P PAID P518007  
A517353  
 A REPAIR

**INDEXED**  
**ON-SITE SEWAGE DISPOSAL SYSTEM**  
**HOWARD COUNTY HEALTH DEPARTMENT**  
**BUREAU OF ENVIRONMENTAL HEALTH**

ADDRESS: 2956 Marriottsville Road PROPERTY OWNER: Wieslaw Deka

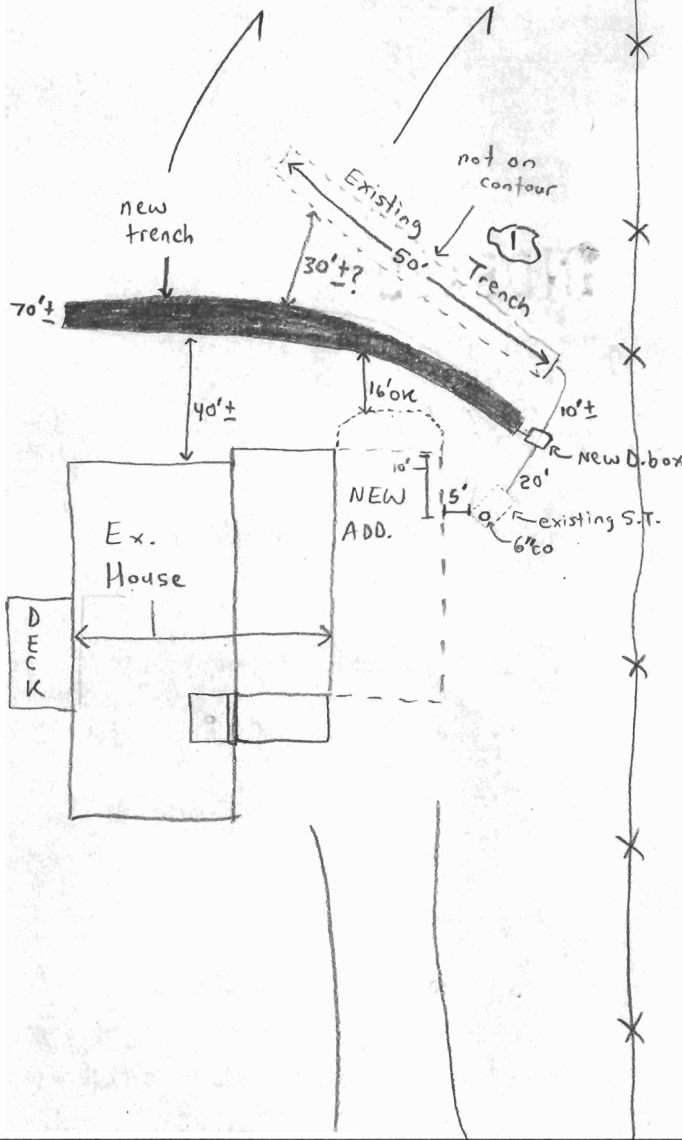
PRE-CONSTRUCTION 11/21/02 - OK TO INSTALL NEW TRENCH ABOVE EXISTING TRENCH TO PREVENT DAMAGING EXISTING TRENCH, OK TO BE LESS THAN 20' TO FOUNDATION W/ NEW TRENCH (SRK)  
 INSTALLATION 11/21/02 - OK TO COVER ALL WORK (SRK)

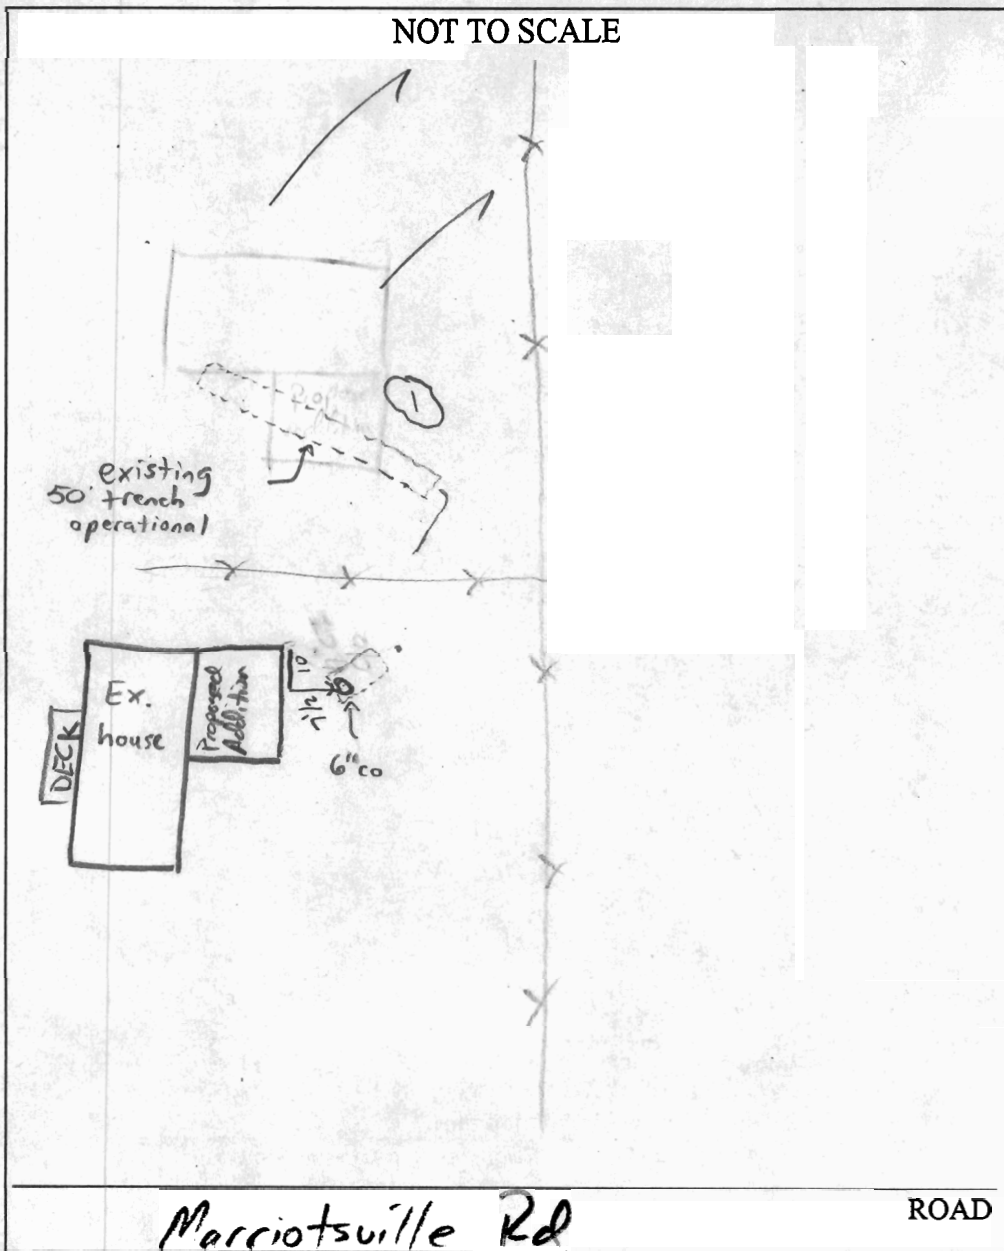
PRE-CONSTRUCTION 7/17/02 - Met contractor on-site + dug perc hole as

shown; see soil profile, keep existing in trench in service (verified by system exposure). Add D-box + connect existing trench w/new trench

INSTALLATION \_\_\_\_\_  
Install manhole covers on tanks + JB/SRK EX. well unable to be found. INSTALLATION -
